Equipment Impacted: Jam Sensors (single function only) located on bulk load conveyance beds, all models, all OEM's.

Issue Description: A PCA was released last year to upgrade jam sensors on bulk loaded conveyance at AIR, ARS, and Sort Center buildings. The general scope requested to upgrade to Q5X JAMAZN Sensors (Model #Q5XKLAF2000-Q8, APN# 41612) and order the corresponding Q5X Mounting Bracket (APN# 41613). The Q5X sensor is purposely used for 24V DC applications. In many cases, sites contained an AC input module such as Figure 1 below, and therefore had existing 120V AC jam sensors to replace.

Figure 2: SPS101SQP

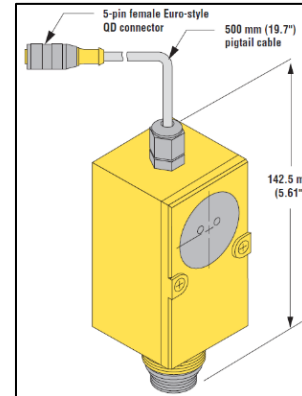
Banner offers a DC Sensor Power Supply (Figure 2) which converts 120 AC line voltage to low voltage DC in order to power the Q5X sensor. The base model number is SPS101SQP and consists of 2 other variations (-ACAB & -ACSK). The wiring diagram variations are compared in Figure 3 below. Table 1 describes the specific applications for each variation from Banner.

Contact Banner to order the applicable DC Sensor Power Supply if you are upgrading 120V AC-powered jam sensors.
